Changes from Rev E to Rev F:

XEROX EOD	Project D0	Memory Control Changes	File d0memchanges.sil	Designer Thacker	Rev Gb	Date 7/18/80
--------------	---------------	------------------------	--------------------------	---------------------	-----------	-----------------

Position c5

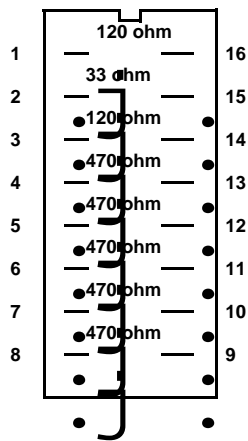
- 1) Changed h7.12 from MC1WriteMem to MC1WriteMemSlow (pg13). This signal is generated at platform a16 (pg12).
- 2) Changed platform a16 to 20pins to make room for MC1WriteMemSlow (pg12).
- 3) Added capacitors on SloMapRAS' and SloMapWrite' (platform c5, page 12).
- 4) Changed a9.12 from MC1Task.3 to MC1Next.4 (pg15).
- 5) Changed i7.1 from PUB to Referenced (pg15). This requires changing PROM i7 to revision E.

- 1) Changed platforms c5 and i1 - removed capacitors and changed values.
- 2) Changed the generation of clkOutputReg' (pg 13). This signal is now one cycle wide, rather than being a qualified EdgeClock.
- 3) The input to h5g (pg 13) is PreRovAd', not EnRowAd'. This board requires an ALU board of rev M for proper operation.

Position i1

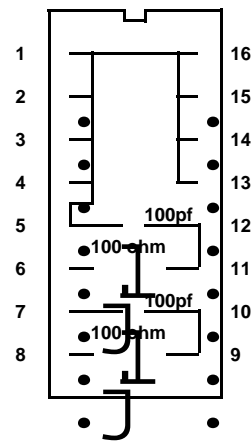
- 1) Signal clkOutputReg is now clkOutputReg' by removing S37 at h6a (now free) page 13.
- 2) b10.1 (pg15) was Disableb10, is now GND. Also removed Disableb10 from SPLAT i1 (pg 12).
